ECE/TRANS/WP.15/AC.2/21/Add.1
22 March 2006

Joint Meeting of Experts on the Regulations annexed to the
European Agreement concerning the International Carriage
of Dangerous Goods by Inland Waterways (ADN)

**Consolidated text of the amendments to the 2005 version of the Regulations
annexed to ADN adopted by the Joint Meeting of Experts**

"5.2.1.9 *Orientation arrows*

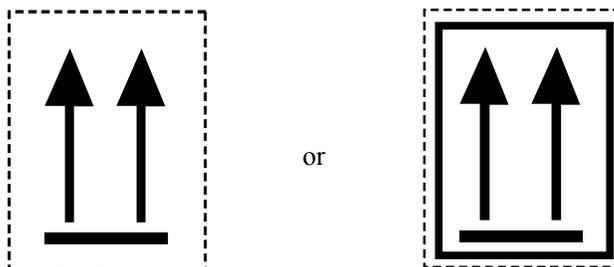
5.2.1.9 Add the following new paragraphs:

shall be legibly marked with package orientation arrows which are similar to the illustration shown below or with those meeting the specifications of ISO 780:1985. The orientation arrows shall appear on two opposite vertical sides of the package with the arrows pointing in the correct upright direction. They shall be rectangular and of a size that is clearly visible commensurate with the size of the package. Depicting a rectangular border around the arrows is optional.

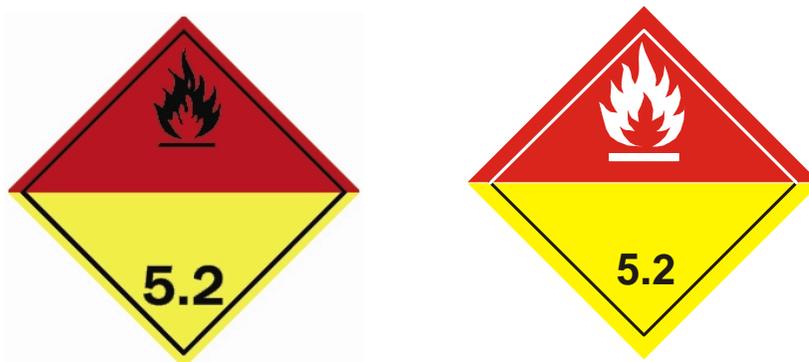
Replace the text under label No. 5.1 with the following:

Symbol (flame over circle): black; Background: yellow

Figure "5.1" in bottom corner"

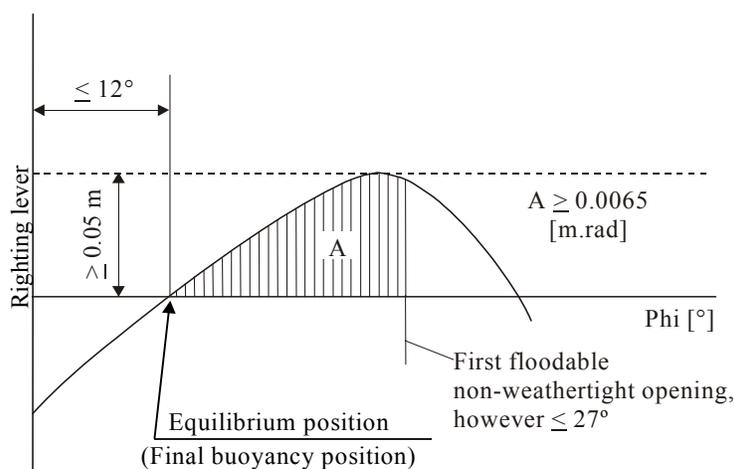
The following provisions are applicable:

- For bottom damage, adjacent athwartship compartments shall also be assumed as flooded;
- The lower edge of any non-watertight openings (e.g. doors, windows, access hatchways) shall, at the final stage of flooding, be not less than 0.10 m above the damage waterline;
- In general, permeability shall be assumed to be 95%. Where an average permeability of less than 95% is calculated for any compartment, this calculated value obtained may be used.

However, the following minimum values shall be used:

- engine rooms: 85%;
- accommodation: 95%;
- double bottoms, oil fuel tanks, ballast tanks, etc., depending on whether, according to their function, they have to be assumed as full or empty for the vessel floating at the maximum permissible draught: 0% or 95%.
